Addendum No. 1

RE: Contract # C204471
WBS # 45446.3.1
FEDERAL-AID NO. NHS-0421(072)
Wilkes County (U-5312)
US-421 FROM EAST OF NC-16 TO US-421 BUS.

The following revisions have been made to the Utility Construction Plans.

LOCATION: US 421 FROM NC 16 TO US 421 BUSINESS IN WILKESBORO
TYPE OF WORK: WATER AND SANITARY SEWER RELOCATION

PROJECT REFERENCE NO.	U-5312	SHEET NO.	UC-19
DESIGNED BY:	B. CLAWSON		
DRAWN BY:	R. MOSS		
CHECKED BY:	B. CLAWSON		
APPROVED BY:			
REVISED:	5/9/23 11/2/23		
MUNICIPAL ENGINEERING SERVICES COMPANY, PA.	P.O. BOX 97 GARNER, NC 27529 (919) 772-5393		
		UTILITY CONSTRUCTION PLANS ONLY

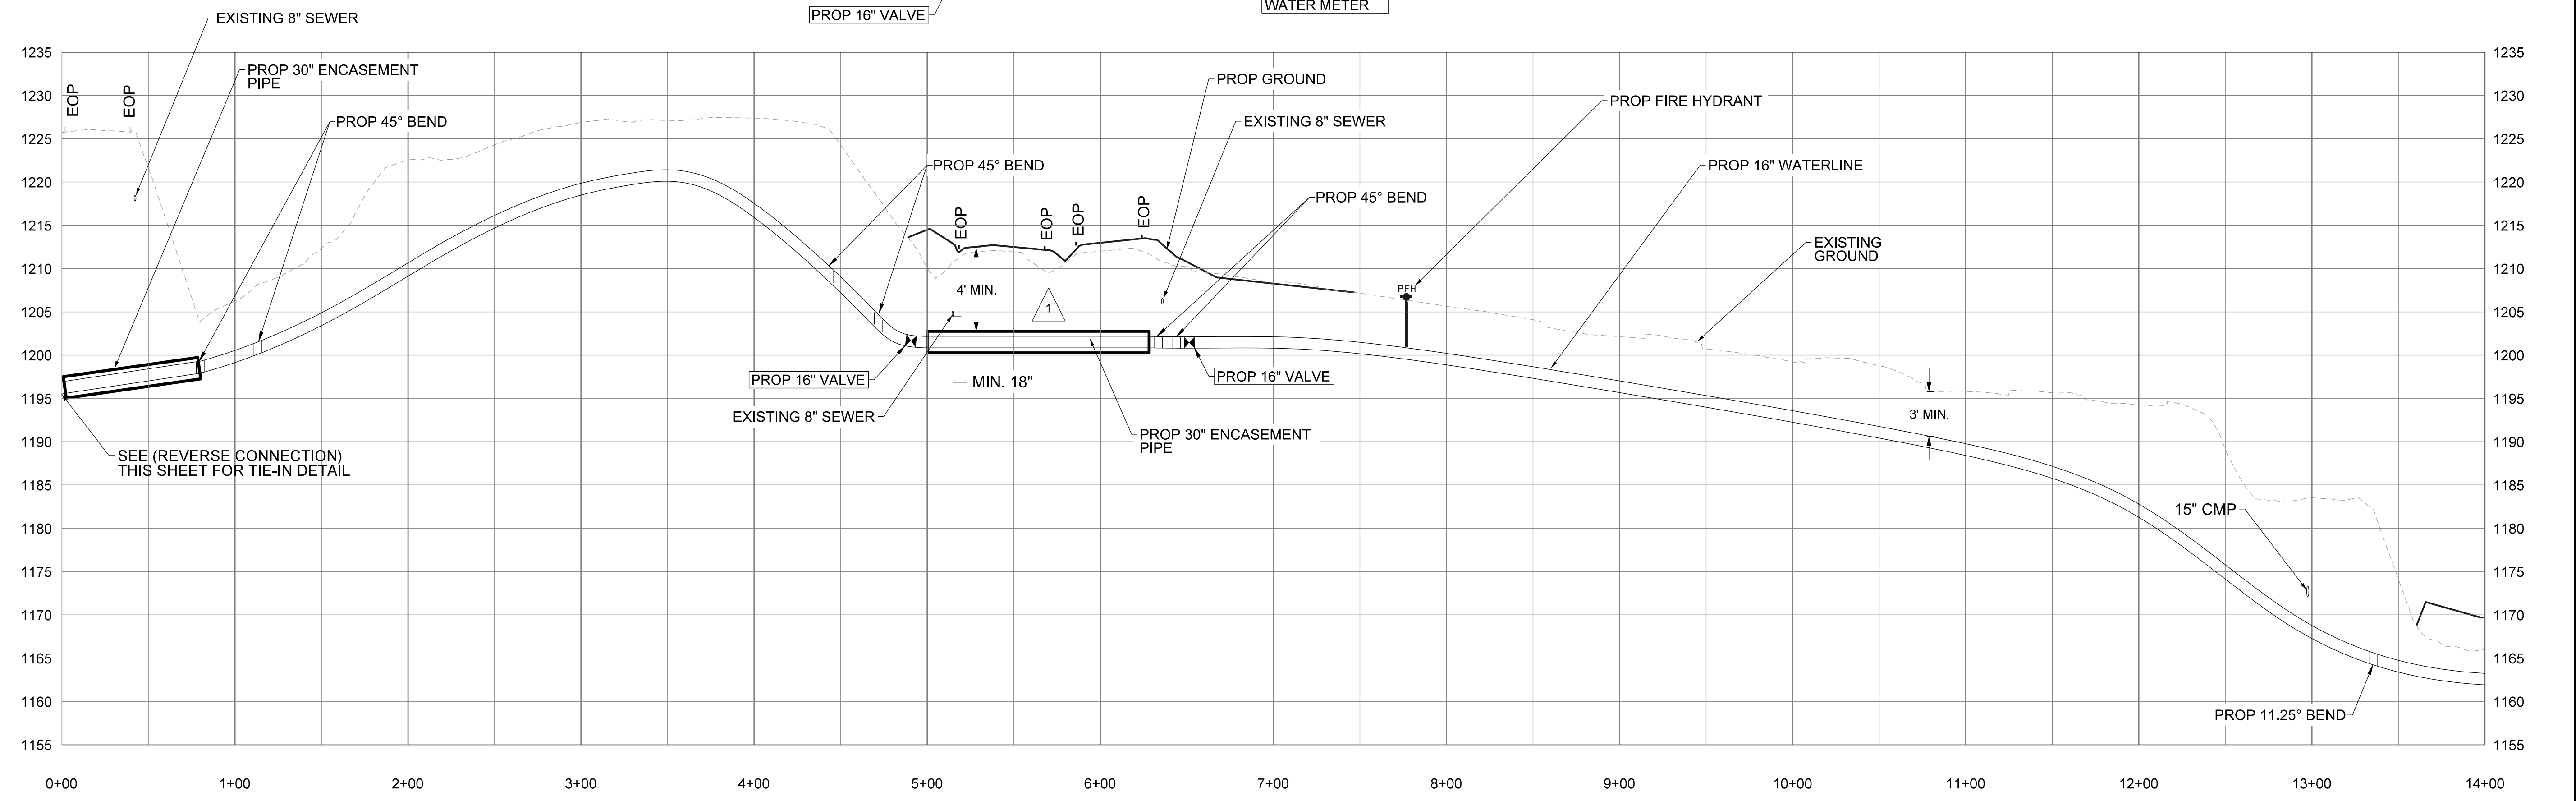
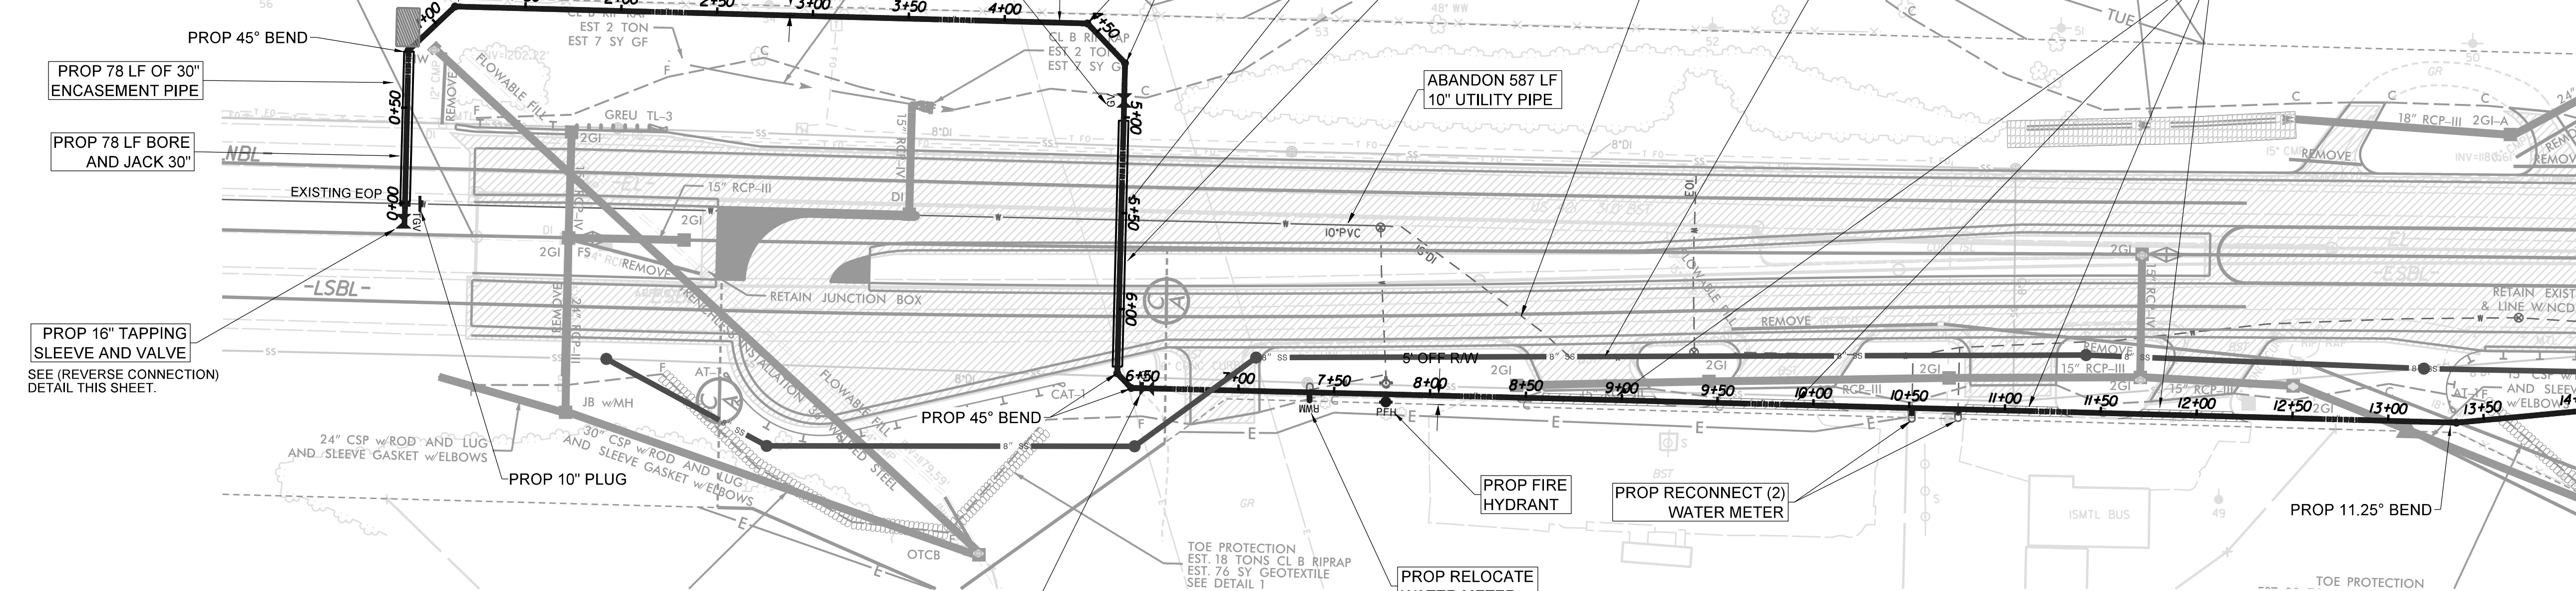
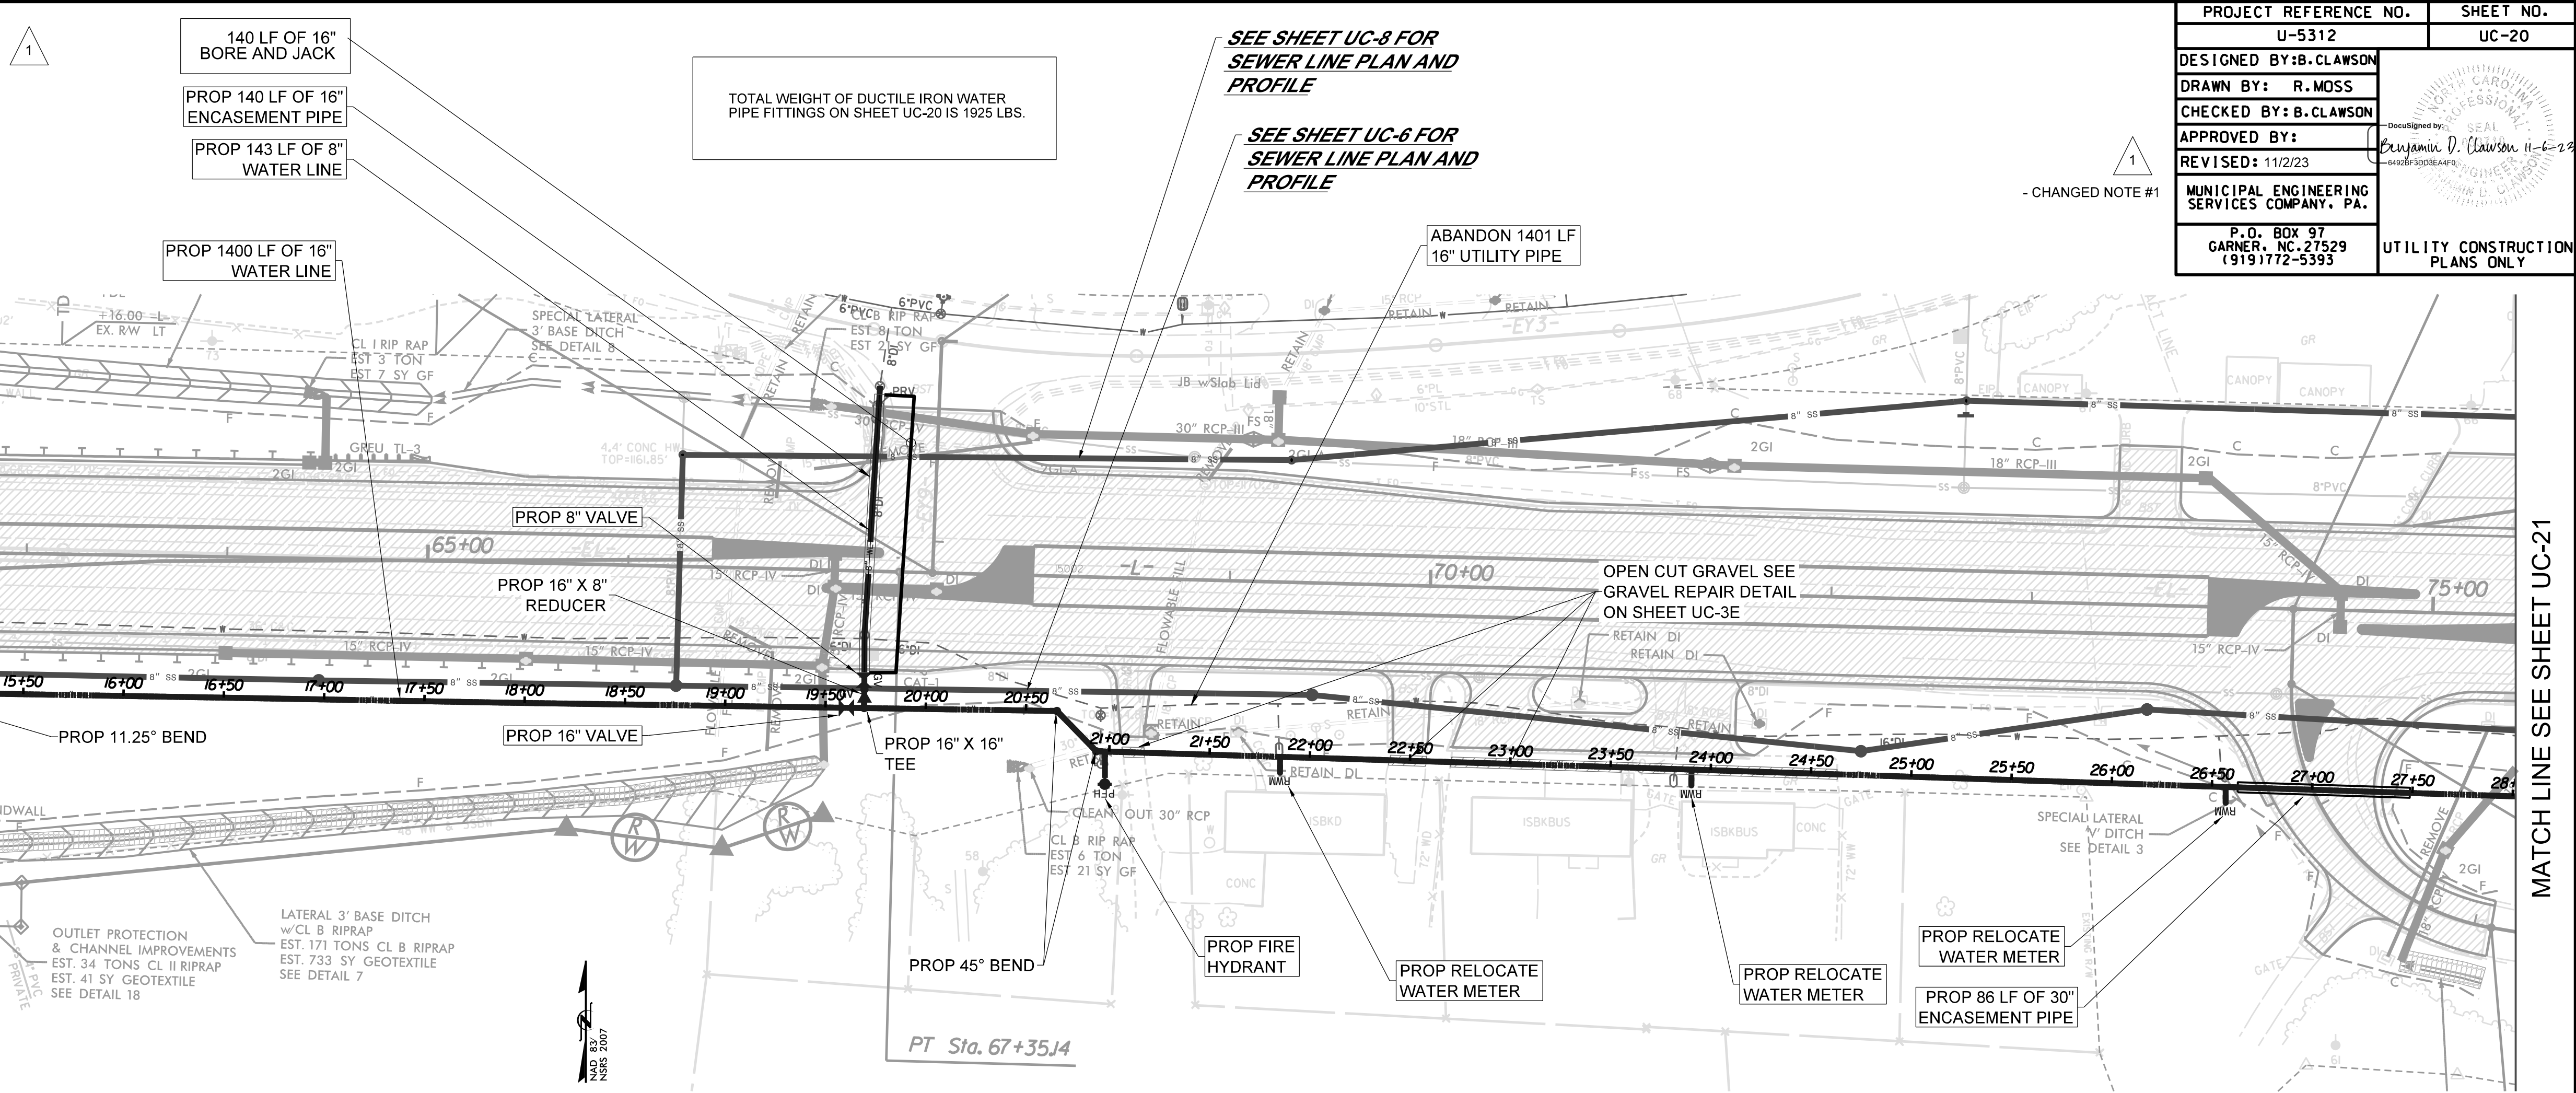
1 - PROVIDED EXTRA CLEARANCE BETWEEN WATER AND SEWER
 2 - CHANGED NOTE #1

NOTES:
 1. WATERLINE MATERIAL SHALL BE: DIP-CLASS 350 (ALL OPEN TRENCH INSTALLATIONS), HOPE-DR7 (DIRECTIONAL BORE INSTALLATIONS), COPPER (SERVICE INSTALLATIONS)
 2. THE CONTRACTOR SHALL VERIFY EXISTING PIPE SIZE AND MATERIAL, AND PROVIDE APPROPRIATE SIZED SLEEVE TO MAKE PROPER CONNECTIONS TO EXISTING PIPE LINES.
 3. WHEN CROSSING PIPE LINES UNDER PROPOSED AND/OR EXISTING DITCHES INSURE THAT PIPE LINE WILL HAVE A MINIMUM OF 4' COVER FROM FINISHED GRADE.
 4. USE RESTRAINED JOINTS AT FIRST TWO JOINTS BEYOND EACH SIDE OF FITTING IN ADDITION TO THRUST BLOCKING AT FITTING.

PROJECT REFERENCE NO.	UC-21
U-5312	
DESIGNED BY: B. CLAWSON	
DRAWN BY: R. MOSS	
CHECKED BY: B. CLAWSON	
APPROVED BY:	<i>Benjamin D. Clawson</i>
REVISED: 11-2-23	
MUNICIPAL ENGINEERING SERVICES COMPANY, PA.	
P.O. BOX 97 GARNER, NC 27529 19191772-5393	UTILITY CONSTRUCTION PLANS ONLY

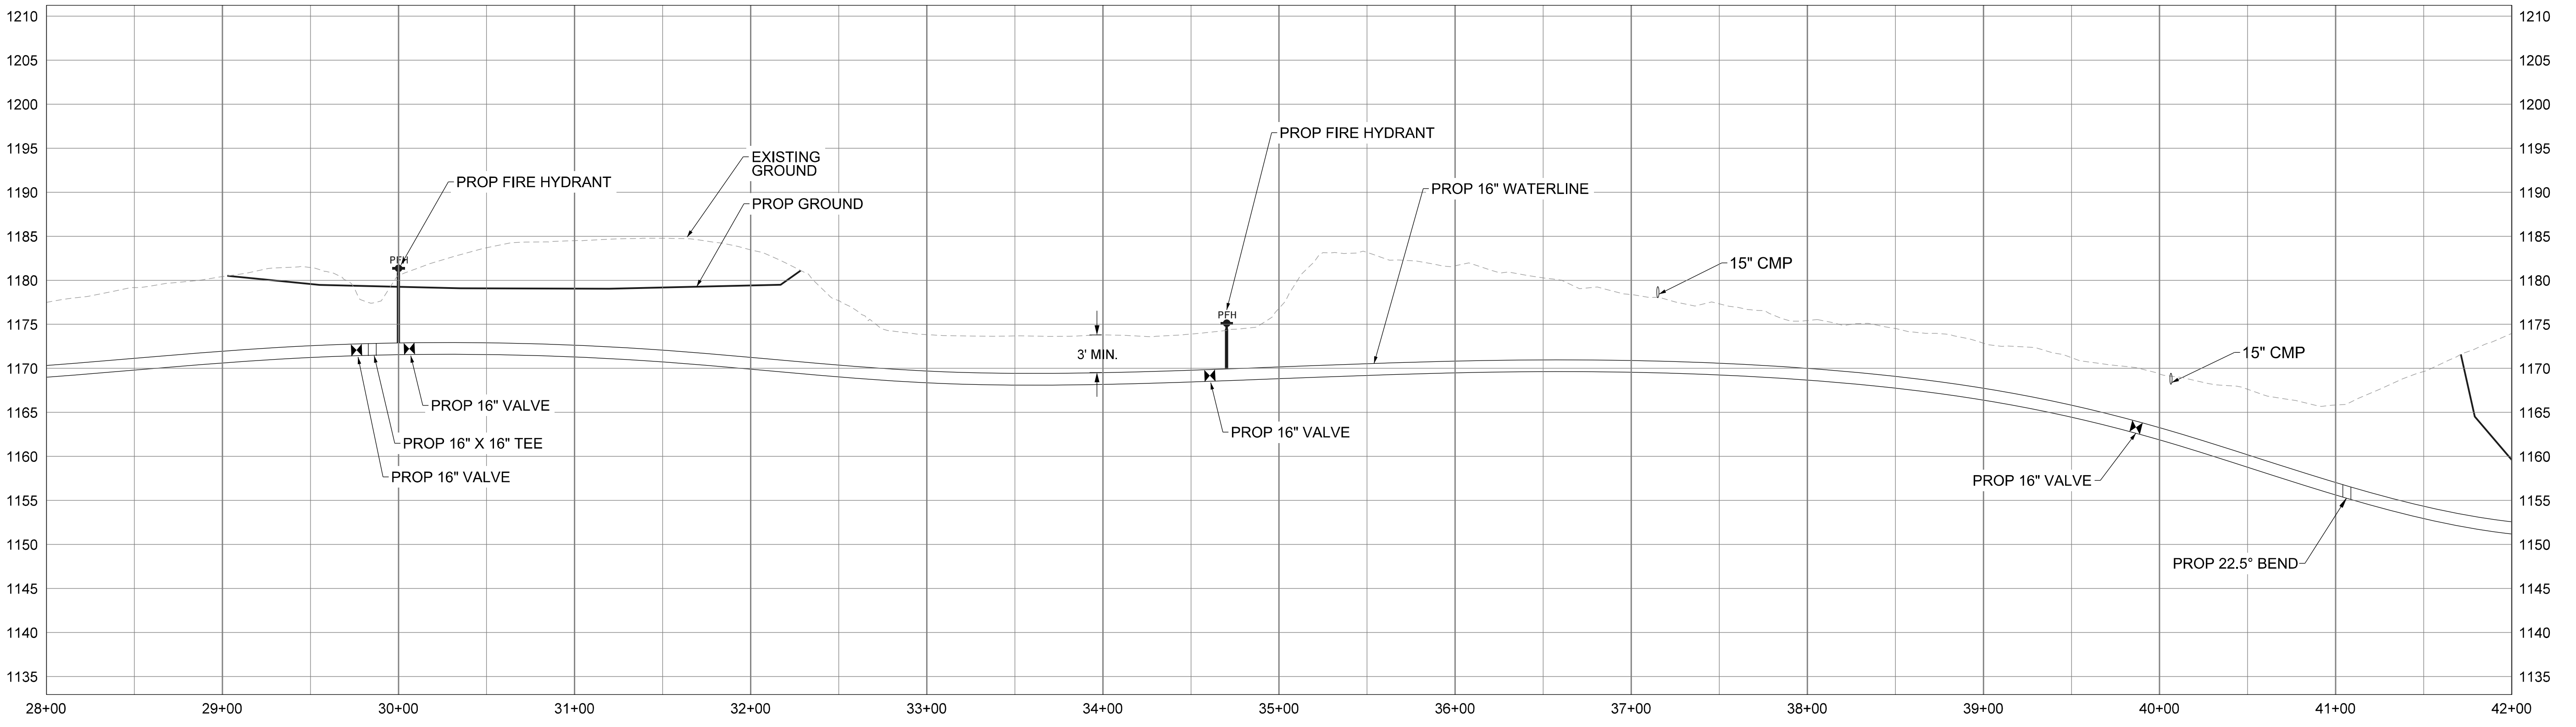
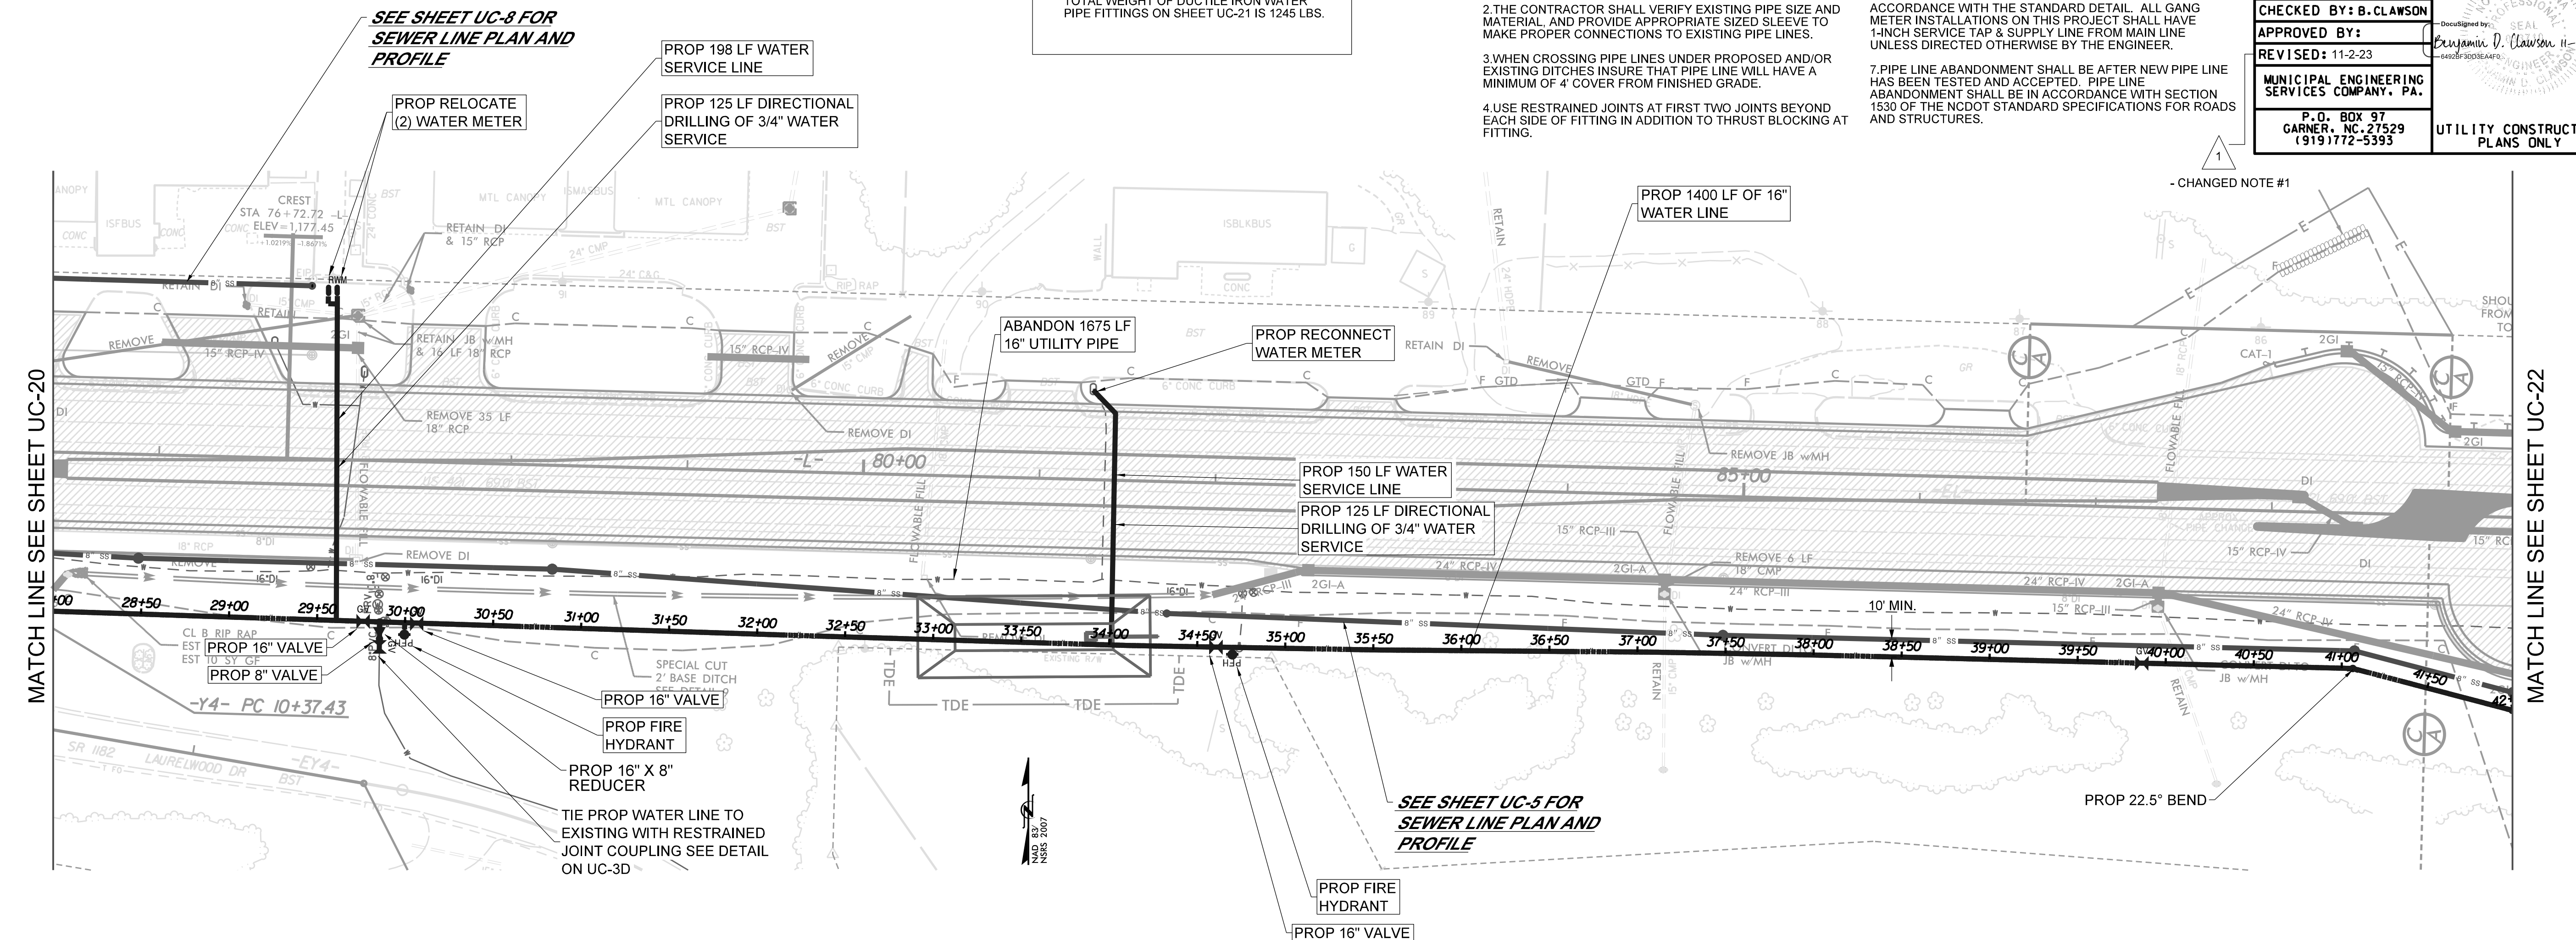
Sheet No.	Revision
UC-21	Revised Note #1 to state "Waterline material shall be DIP-Class 350 (All Open Trench Installations), HDPE-DR7 (Directional Bore Installations), Copper (Service Installations)". Labels added for Proposed 16" Valve and Proposed Fire Hydrant.
UC-22	Revised Note #1 to state "Waterline material shall be DIP-Class 350 (All Open Trench Installations), HDPE-DR7 (Directional Bore Installations), Copper (Service Installations)".
UC-23	Revised Note #1 to state "Waterline material shall be DIP-Class 350 (All Open Trench Installations), HDPE-DR7 (Directional Bore Installations), Copper (Service Installations)".
UC-24 thru UC-25	North arrow added. Additional detail for benched exaction trenching provided in profile. Revised Note #1 to state "Waterline material shall be DIP-Class 350 (All Open Trench Installations), HDPE-DR7 (Directional Bore Installations), Copper (Service Installations)".

- NOTES:
1. WATERLINE MATERIAL SHALL BE: DIP-CLASS 350 (ALL OPEN TRENCH INSTALLATIONS), HDPE -DR7 (DIRECTIONAL BORE INSTALLATIONS), COPPER (SERVICE INSTALLATIONS)
